## **URGENT – Field Safety Notice**

To all users of the FUJIFILM DR-XD1000 (FDR Nano)

### **Re: FUJIFILM DR-XD1000 (FDR Nano) - Countermeasure to strengthen the arm & to replace the incorrectly installed mirror inside the Collimator Assembly**

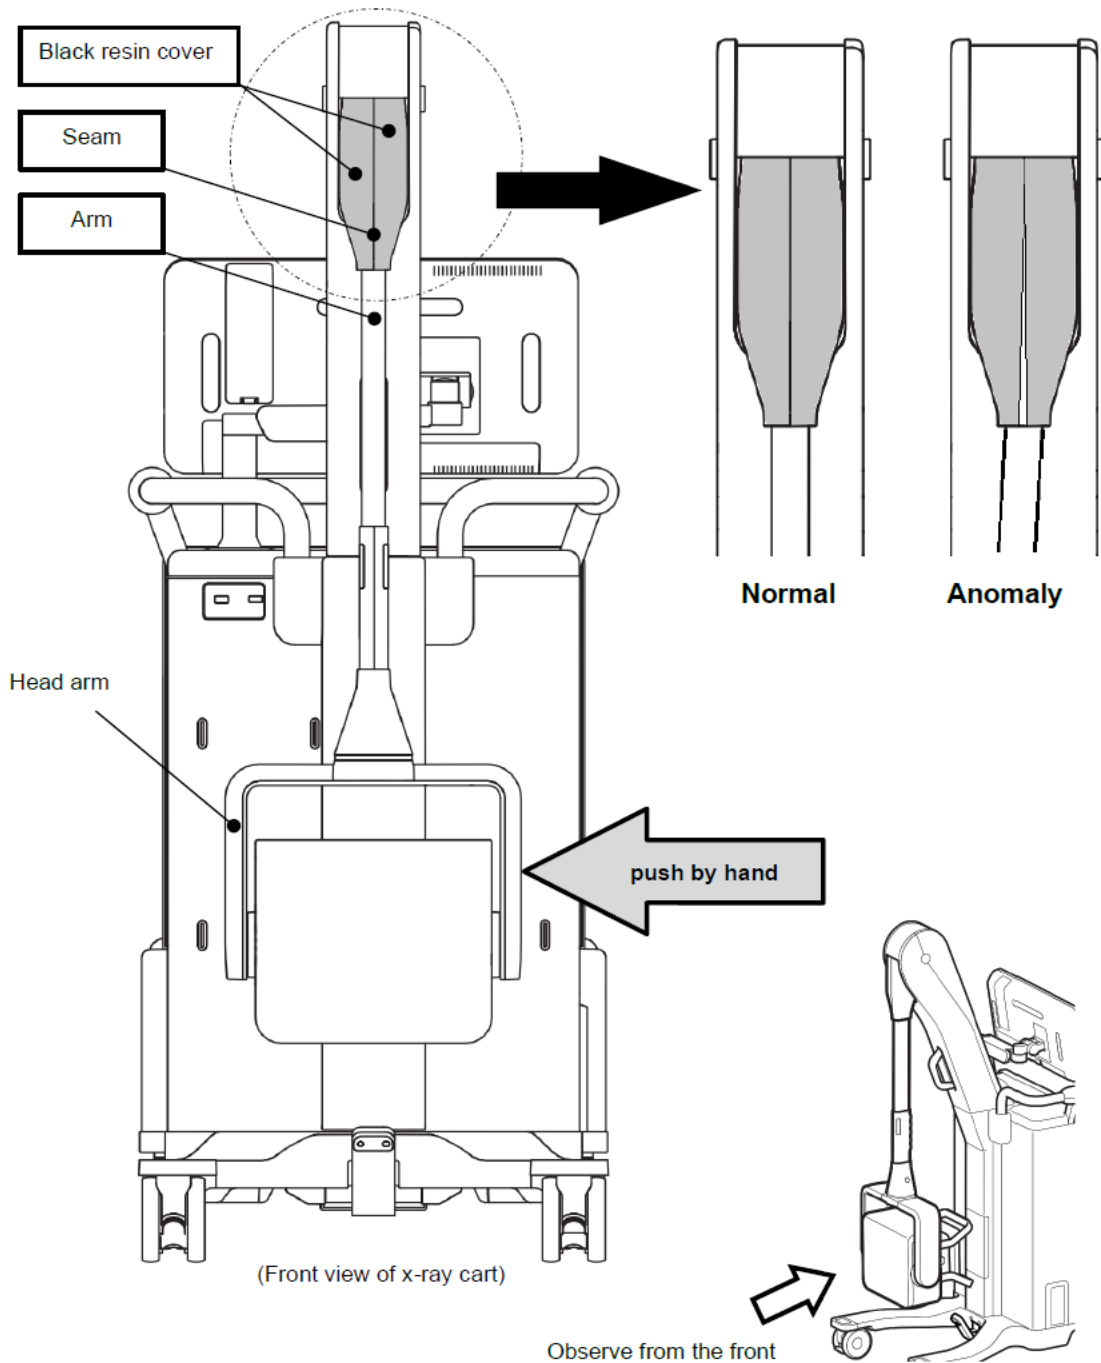
3. Push the head arm from the side and check the following from the front.  
If there is any abnormality, please stop using it and contact the contact information listed on page
  - 1) Make sure that the gap between the seams of the resin cover does not widen.
  - 2) Make sure that the arm does not tilt against the resin cover

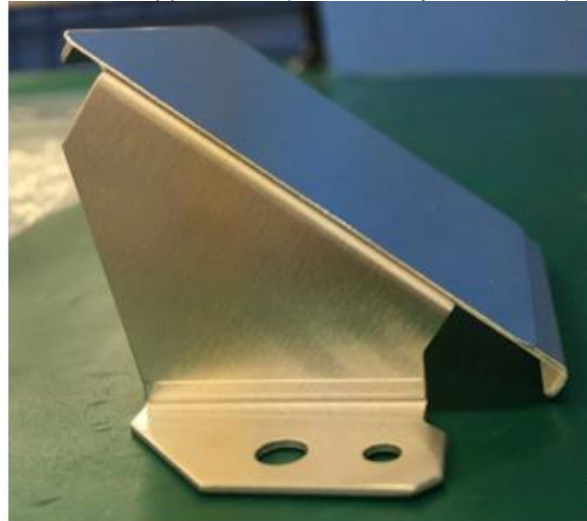
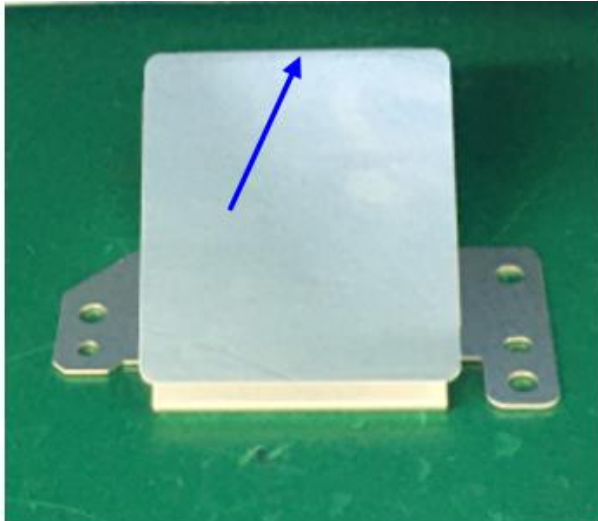
Fujifilm has become aware that the positional deviation between the light field indicator and the X-ray irradiation field may exceed the standard (within 2% of the SID). Since the deviation does not comply with "IEC60601-2-54 203.8.102.6 Accuracy of Indication with a Light Field-Indicator".

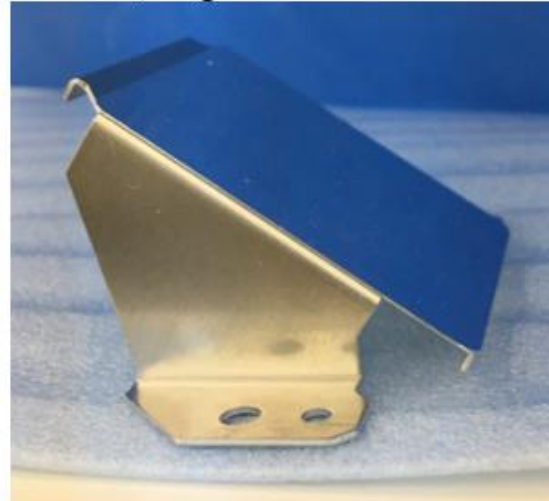
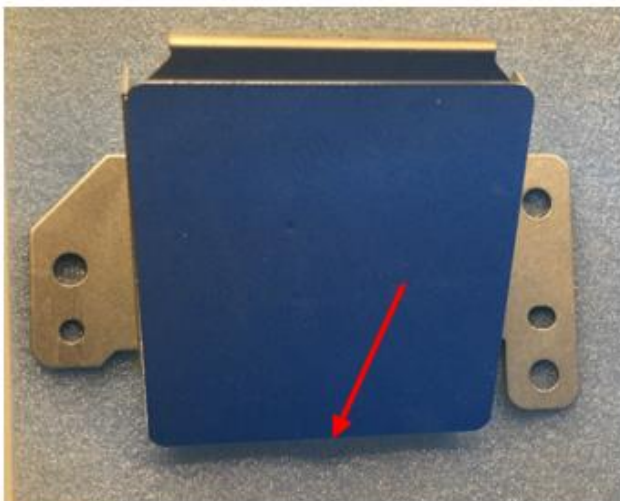
Inside the Collimator Assembly, the mirror is attached to the bracket incorrectly.

**Correct:** The mirror is attached to the bracket, aligned with the upper bend (indicated by blue arrow).

**Incorrect:** The mirror is attached to the bracket, aligned with the lower bend (indicated by red arrow).

◇Description of the countermeasure kit

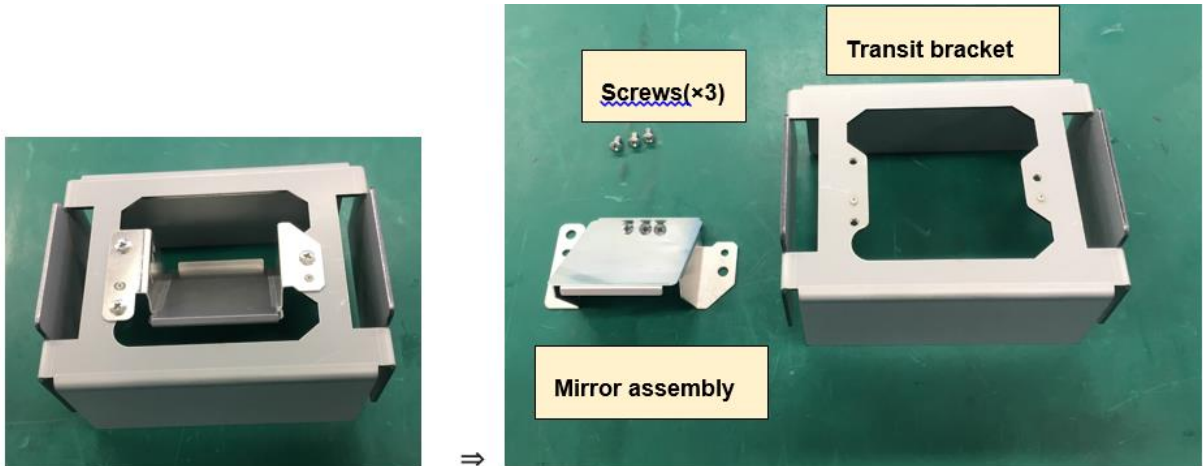
- Countermeasure Kit No. : EXZT1004
- Contents  
Mirror assembly (in transit bracket)
